date: January 24, 2025
to: Friederike H. Mittner, FAICP, Design and Preservation
Manager, Town of Palm Beach
from: Eric Czerniejewski, P.E., ENV SP
subject: Society of Four Arts Traffic Review

MEMORANDUM

The Corradino Group, Inc. (Corradino) has been requested to provide a traffic review of the Traffic Impact Evaluation and Parking Evaluation for the Society of the Four Arts redevelopment located at 100 and 102 Four Arts Plaza in the Town of Palm Beach, Florida. The following are our traffic review comments based on the 11/01/24 resubmittal.

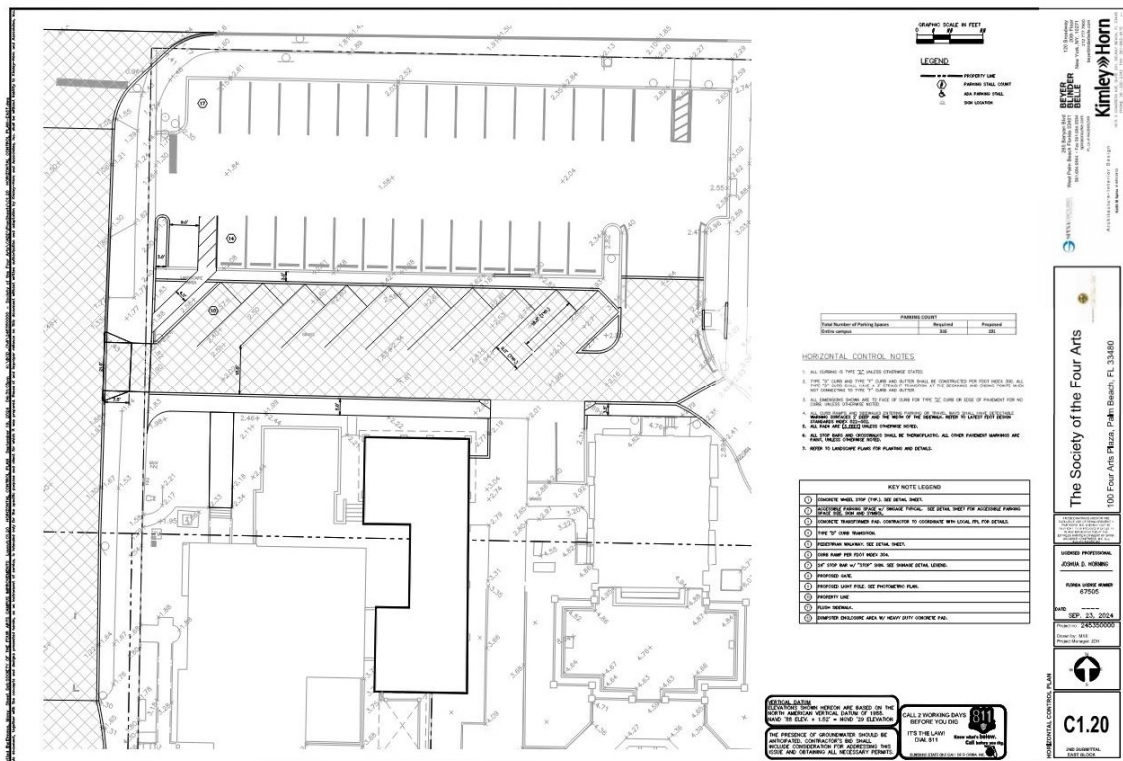
5. Please update Figure 3 to match the total site generated trips with the driveway volumes for the proposed scenario per Table 2. Figure 3 has 80 AM inbound and 17 AM outbound trips. Figure 3 has 71 PM inbound and 99 PM outbound trips.

Kimley Horn and Associates, Inc.'s 08/09/24 Response: The trip volumes in Figure 3 have been revised for consistency in the updated report.

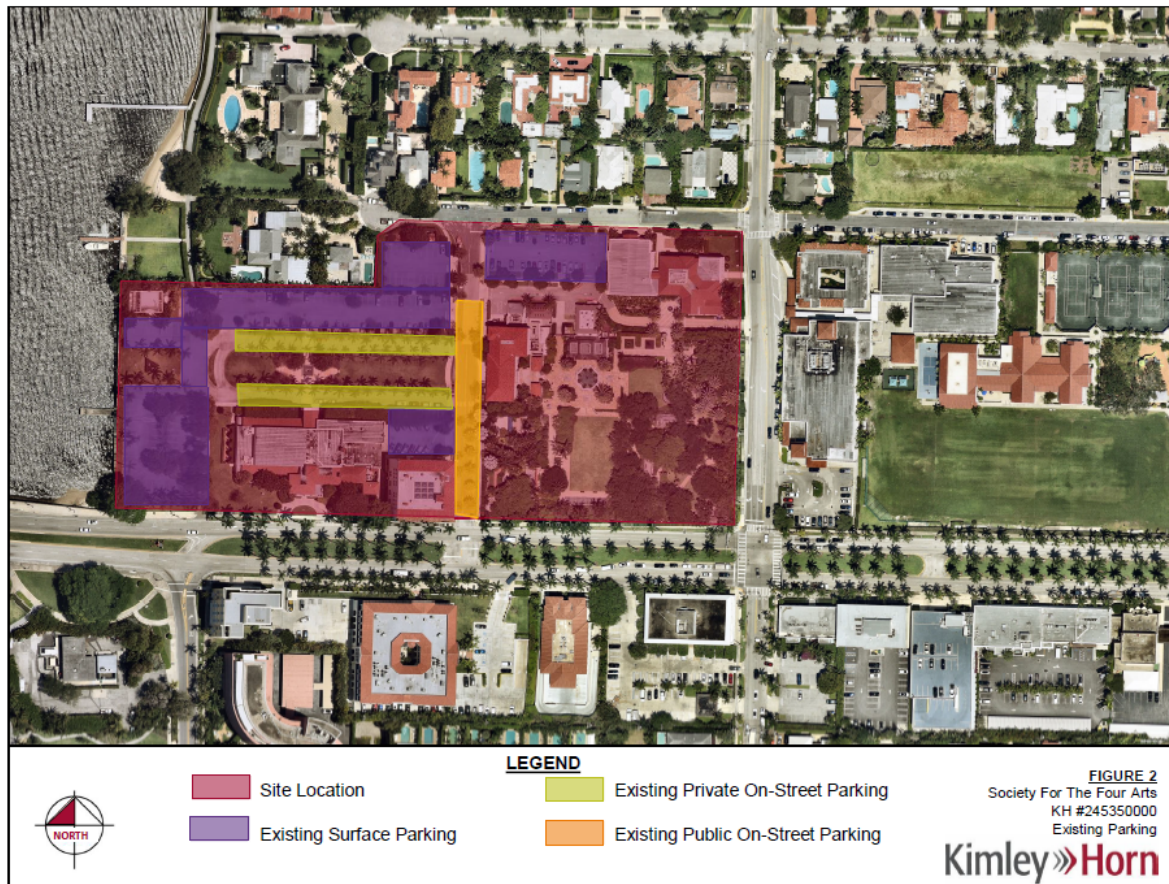
6. Please provide a pavement marking and signage plan signed and sealed by a professional engineer in the State of Florida for the on-site development. This should include all stop control at the proposed ingress and egress driveway locations. Please provide ADA handicap parking details per MUTCD and local Palm Beach criteria. Safe sight triangles per appropriate agency stakeholder standards should be depicted and match the proposed landscape design plans.

TCG 08/16/24 Response: This item is still pending. A copy of the pavement marking and signage plan was not included as part of the 08/09/24 resubmittal.

TCG 10/04/24 Response: This item is still pending. Plan sheet C.120 is a horizontal control plan and does not provide a complete representation of all of the pavement, marking and signage revisions to the entire campus. Please provide pavement, marking and signage plans for all proposed design revisions for the entire campus. The plan should update the parking count table that calls out the 191 proposed parking spaces. This table should reflect the 223 parking spaces, including the 42 stabilized grass surface parking spaces.

Kimley Horn and Associates, Inc.'s 10/07/24 Response: The requested additional pavement marking & signing information has been added to sheet C1.20 and is included in the updated submittal package.

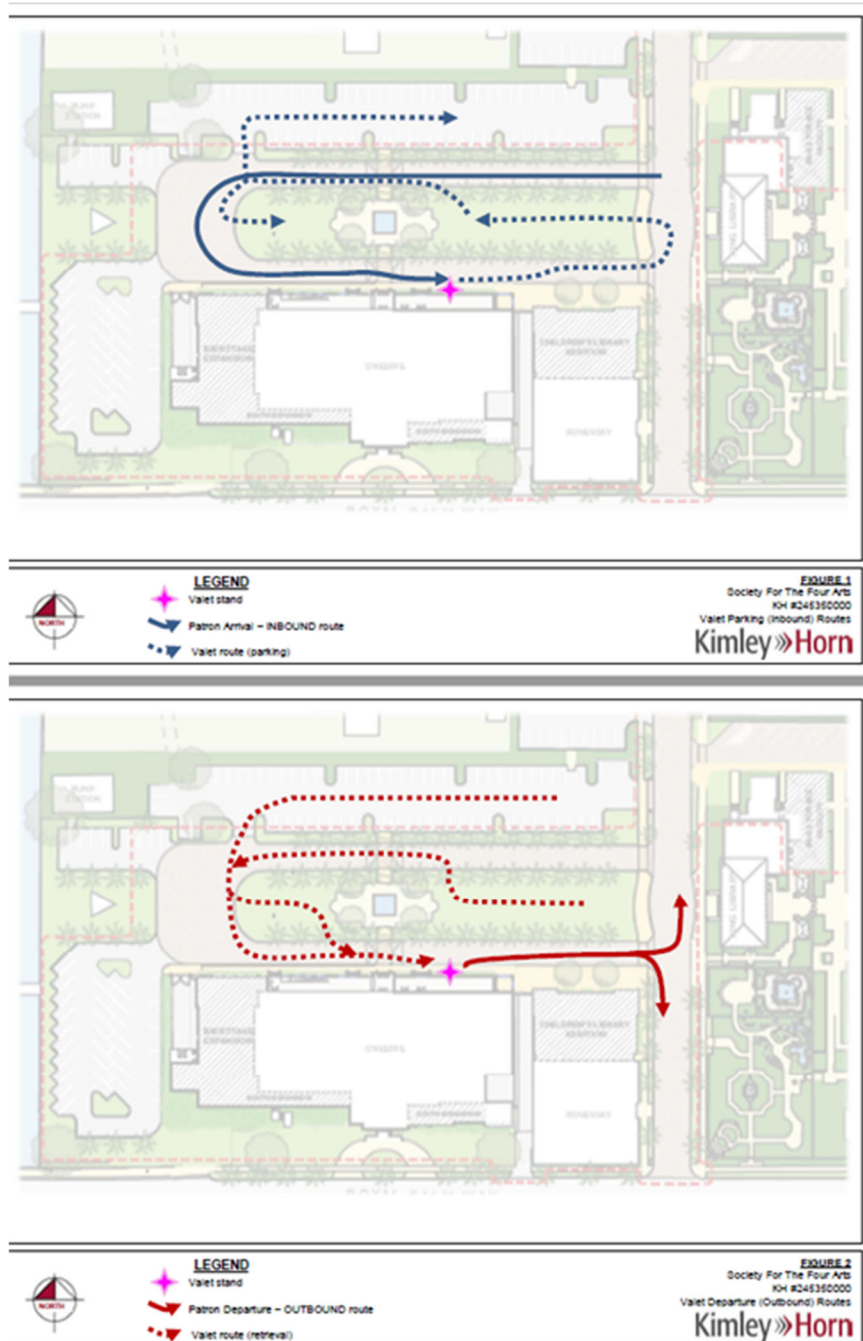
13. Please provide site plan that depicts the site parking available on-site and includes a site parking data table that provides details on the required parking per the Town of Palm Beach Code of Ordinances and details required the Modified Parking based on the provided Parking Requirements Evaluation.

Kimley Horn and Associates, Inc.'s 08/09/24 Response: The requested information is provided as a part of the site plan architectural package.
